# Comparison of 2021 IECC Residential Cost Effectiveness Analyses

This document is intended to provide a comparison of two reports the *2021 IECC Residential Cost Effectiveness Analysis* published for the National Association of Homebuilders (NAHB) by Home Innovation Research Labs (HIRL) in June 2021, hereafter referred to as the HIRL report<sup>1</sup>; and the report of the same name published by ICF in June 2022, hereafter referred to as the ICF report. The purpose of this document is to identify concerns and issues in the HIRL report, which were addressed in the ICF report.

Figure 1: Comparison of Builder Gross Profit Margin

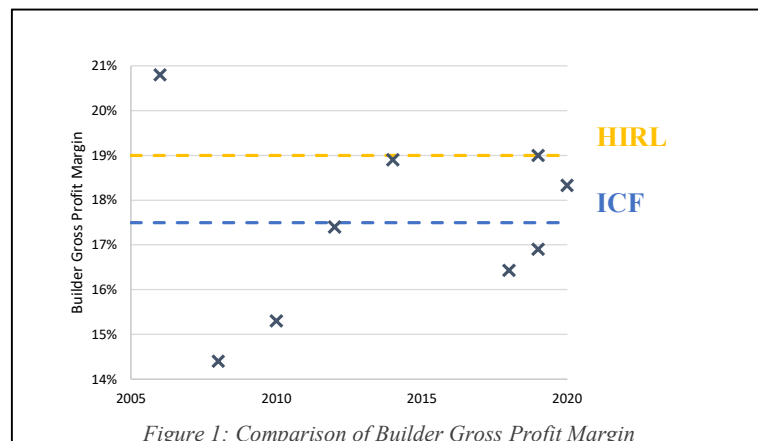
The HIRL report stated that the total cost to the consumer included a builder's gross profit margin of 19%. Several issues were found with this, leading to higher costs which would negatively impact cost effectiveness.

The ICF report considered changes in builder profit margins over time and used an average value representing all data that was available. Figure 1 shows the data available for builder gross profit margin as black X's, with their average – the value used in the ICF report – shown by the blue line. The profit margin used in the ICF report is a more representative value, as HIRL report value is the highest profit margin seen since 2006.

Figure 2: Comparison of 2021 IECC Code Change Costs

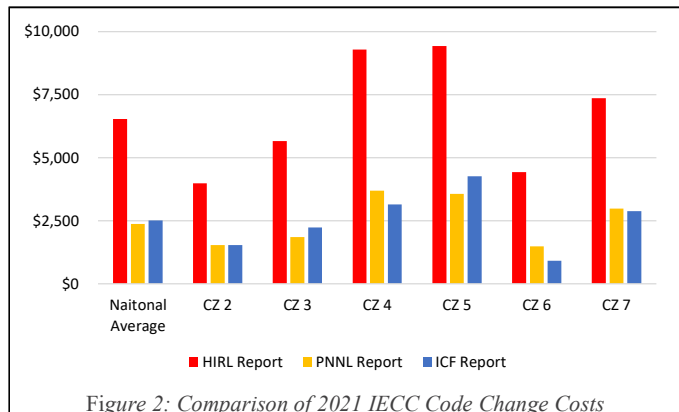
When reviewing the HIRL report, the high estimated incremental cost of code changes conflicted with other data sources, specifically Northwest national Laboratory's (PNNL's) *National Cost Effectiveness of the Residential Provisions of the 2021 IECC*, as shown in Figure 2.<sup>4</sup> After reviewing and updating cost data, the ICF report concluded costs were generally in line with the PNNL report, instead of 2 to 3 times higher as shown in the HIRL report.

Figure 3: Comparison of Energy Cost Savings

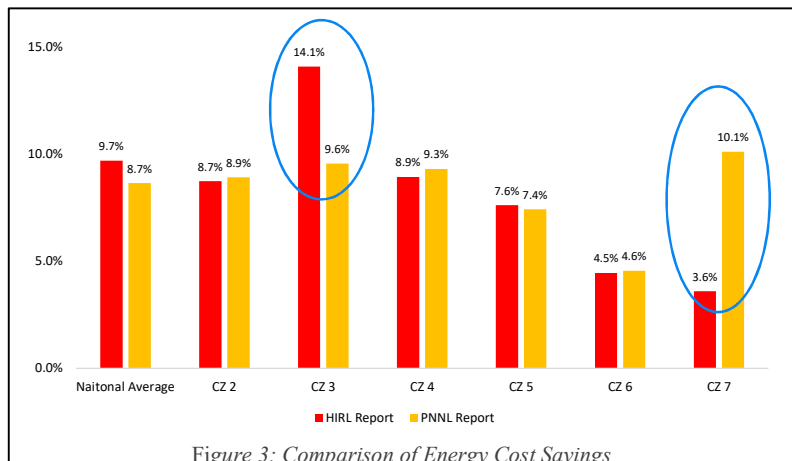
Savings from the HIRL report and PNNL's savings estimates (*Energy Savings Analysis: 2021 IECC for Residential Buildings*<sup>5</sup>), were compared and national average savings were comparable (9.7% for HIRL and 8.7% for PNNL). However, some results in specific climate zones showed significant differences as shown in Figure 3 (i.e., climate zones 3 and 7). Due to the robustness of the methodology that PNNL's savings estimates used, it is likely that there is an issue with the modeled energy use in the HIRL report. However, this cannot be confirmed, nor could the potential impact on the cost-effectiveness be determined.
